Re:FCC ID QLA800MHZ
Applicant: Mala GeoScience AB (publ)
Correspondence Reference Number: 24222
731 Confirmation Number: EA813498

Figure 1. Pulse characteristic of a 800 UWB-unit.

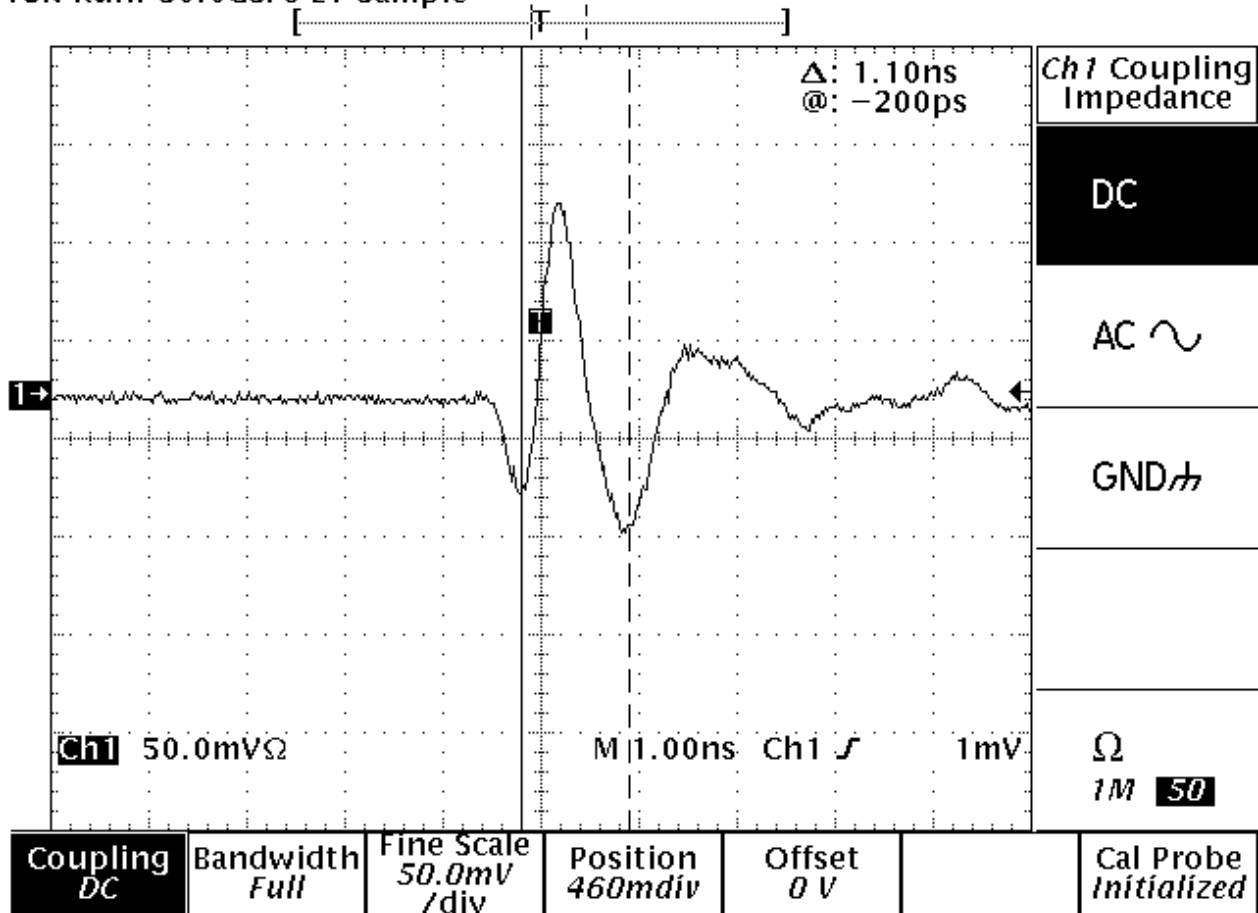
9) What is the pulse width of this device. Is the pulse random (dithered) or periodic? Upload an exhibit with the pulse characteristics of this device. Include a plot.

The 800 MHz antenna/UWB-unit has a pulse width of about 1.1ns, in air. A plot of the pulse is shown in figure 1 below. The pulse is periodic with a repetition frequency of 100 kHz.
